ADDITIONAL AMENDMENTS

AMENDED
Notes

PROPOSED CONVERSION OF BARNS TO BUNK HOUSE / HOLIDAY COTTAGE,
LOW WAUPLY FARM, EASINGTON, SALTBURN BY SEA

DRAWING No. 07/130/01^D

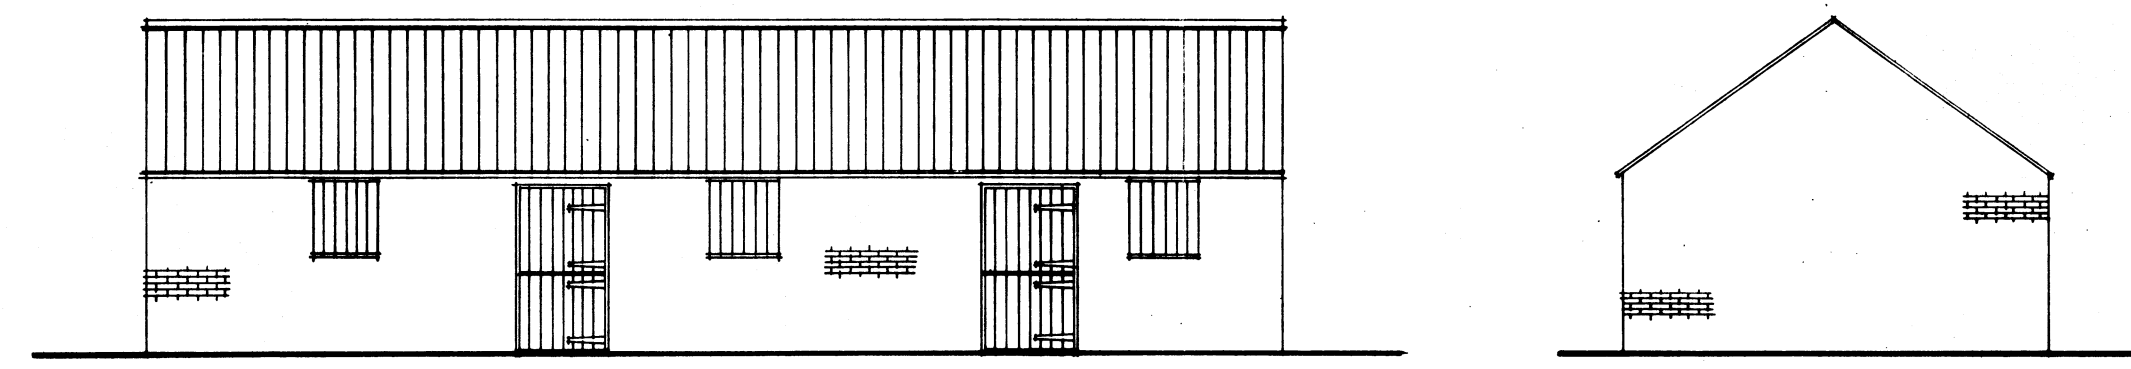
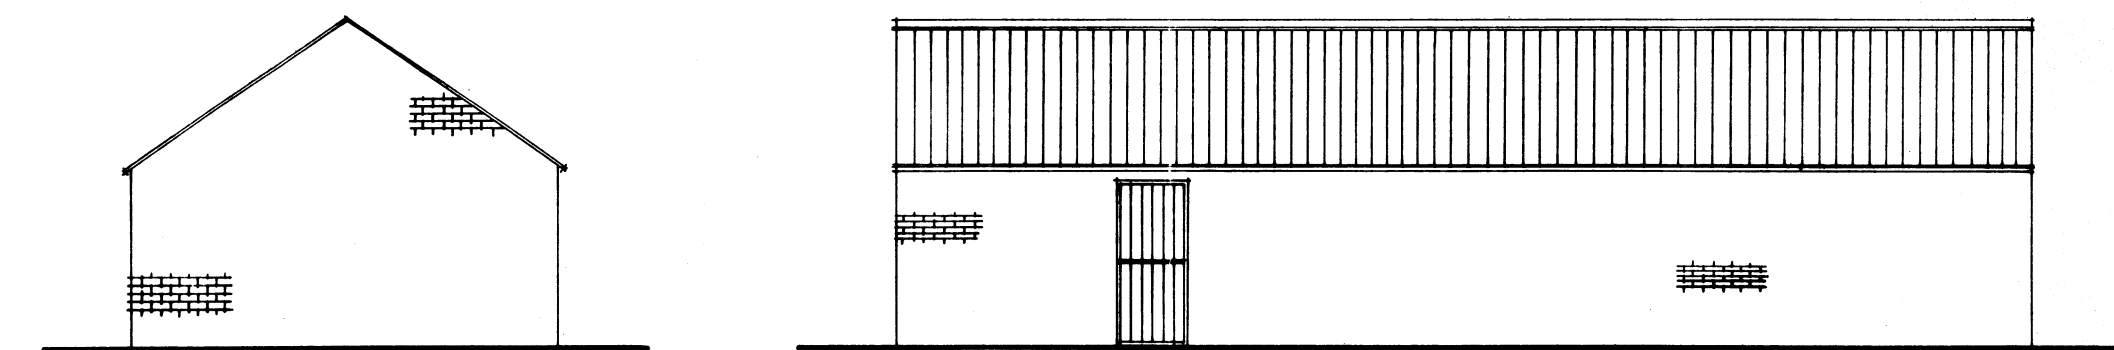
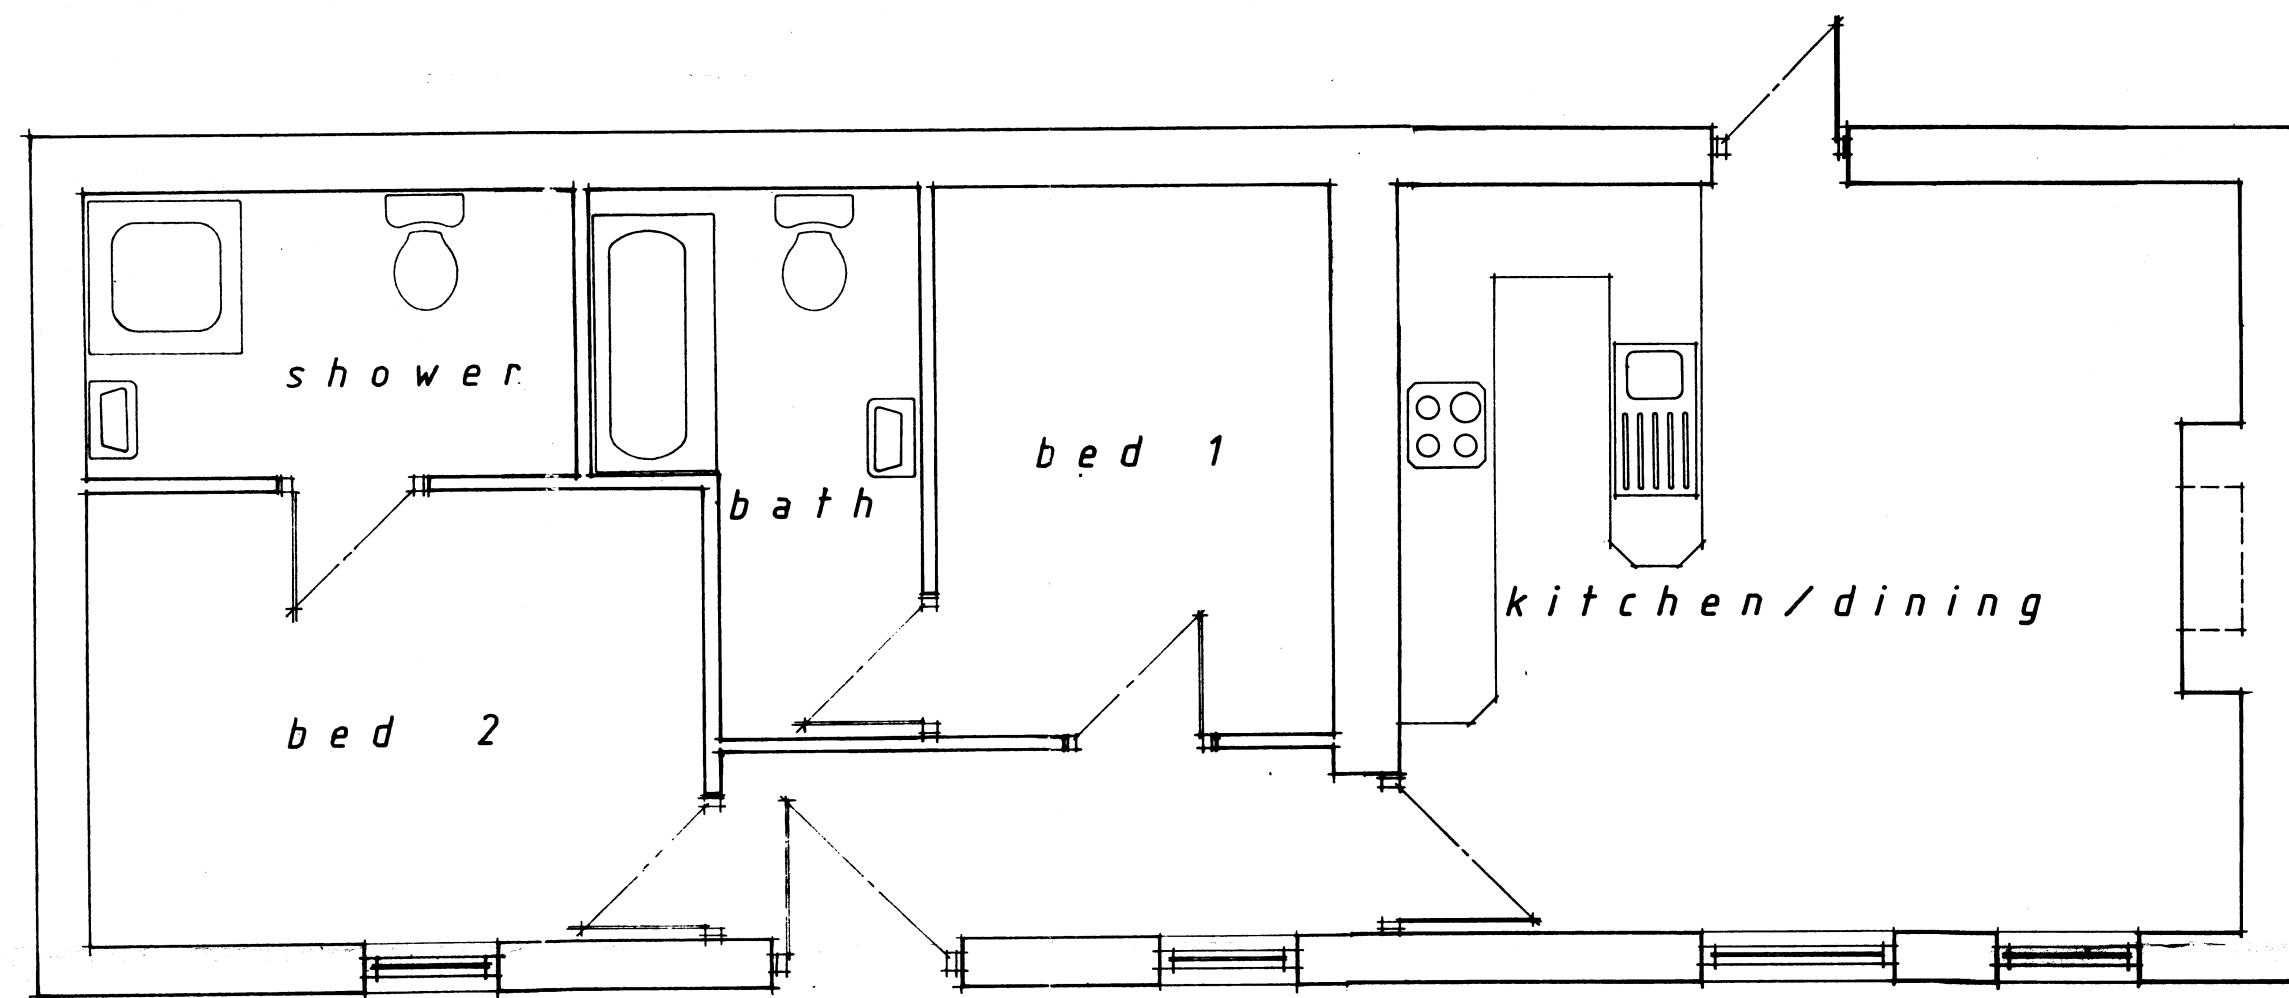
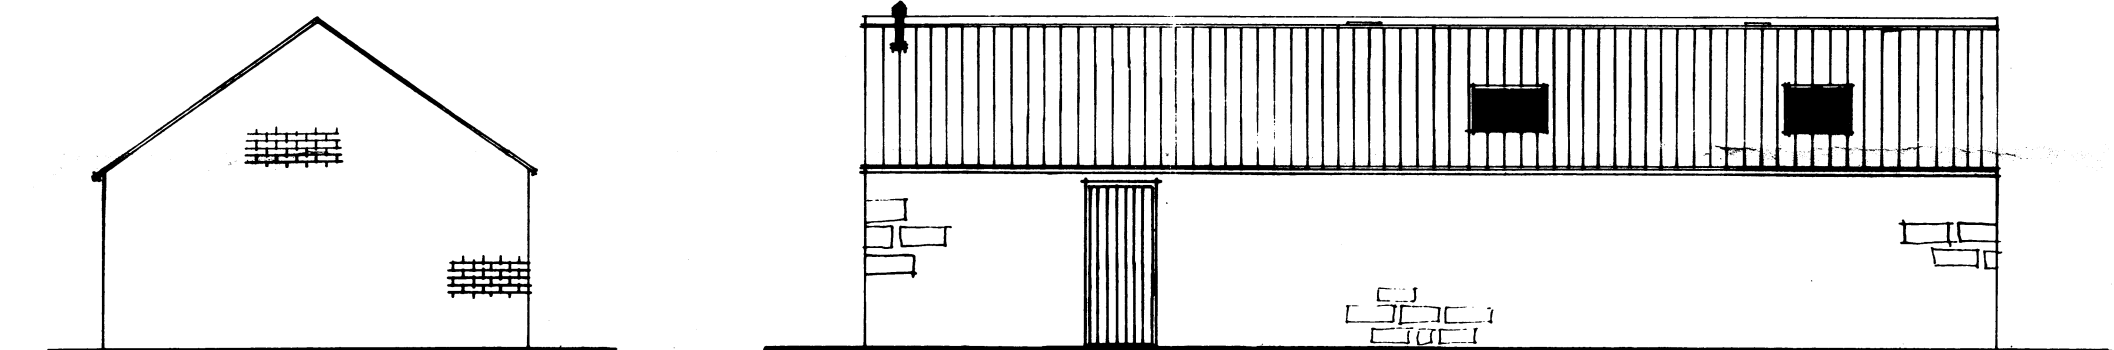
No.	DESCRIPTION	CHK'D	APP'D	DATE
D	SUN ROOM REMOVED			13.12.07
C	LAYOUT AMENDMENTS - CLIENT REQUEST			8.12.07
B	LAYOUT AMENDED - BETH DAVIES COMMENTS			24.11.07
A	SHOWER REMOVED			
ALTERATIONS
